HGY/2025/1220 Depot, 505-511 Archway Road, London, N6 4HX

Redevelopment of existing car wash site to provide 16 new council homes comprising a 4-storey building fronting Archway Road and two 2-storey houses fronting Baker's Lane, with associated refuse/recycling stores, cycle stores, service space, amenity space and landscaping.

Summary

**Map of Gaskell Estate and nearby locally and nationally listed buildings, taken from Highgate Conservation Area Character Appraisal and Management Plan, Chapter 9.
(Approx extent of Depot site added for clarity.)**

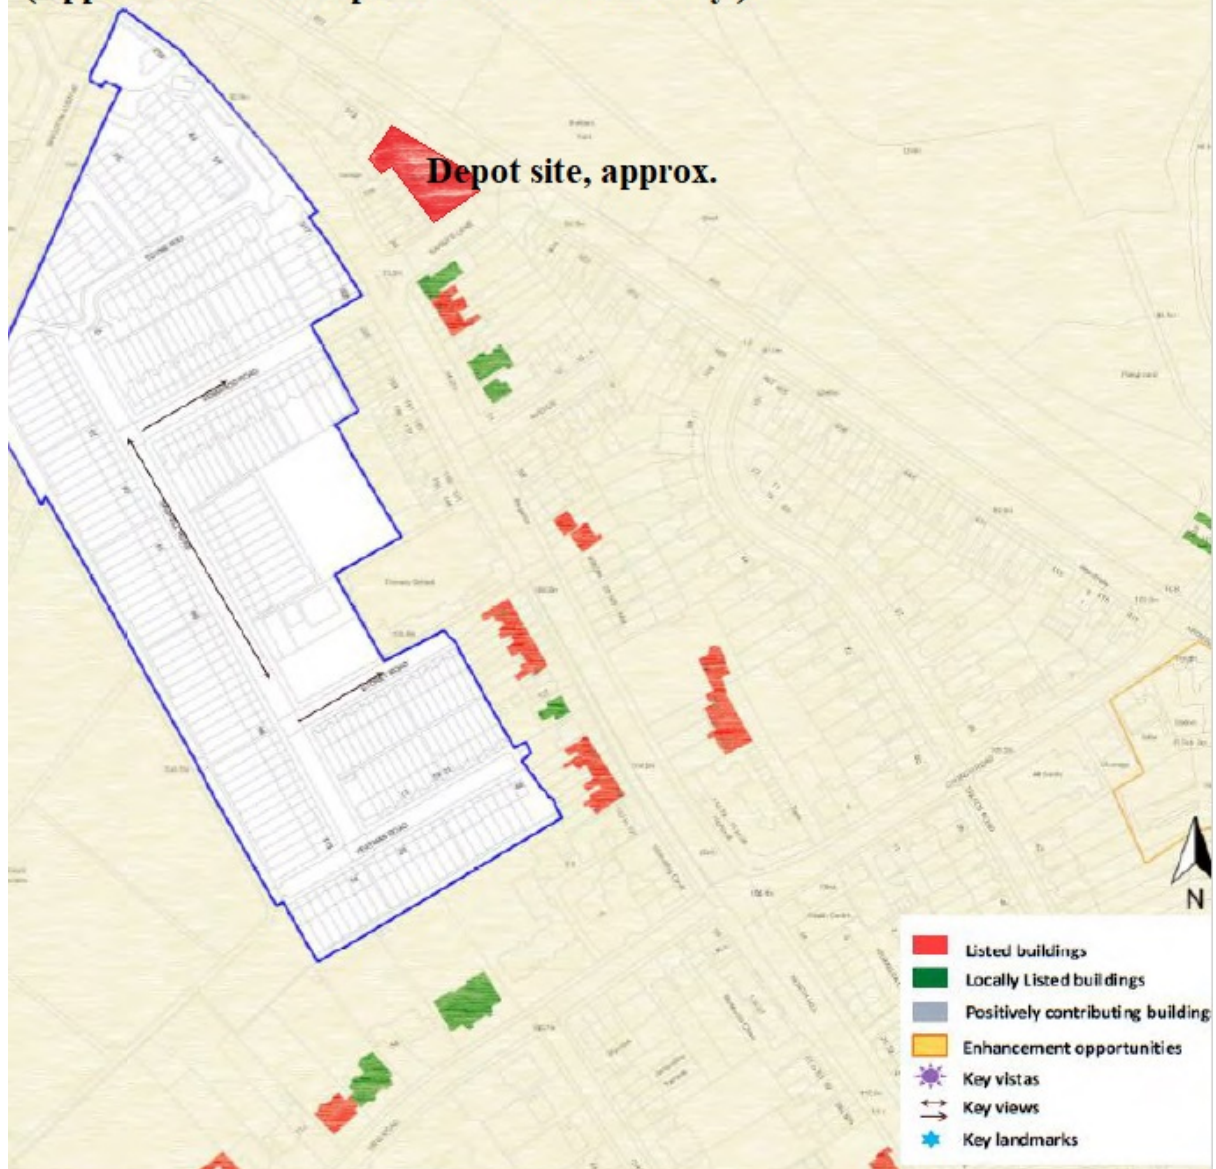
This application would, amongst other things, cause harm to the Gaskell Estate not justified by public benefit.

The Depot site viewed from Kenwood Road on the Gaskell Estate. The proposed block would be completely out of character and adversely effect the setting of the estate.
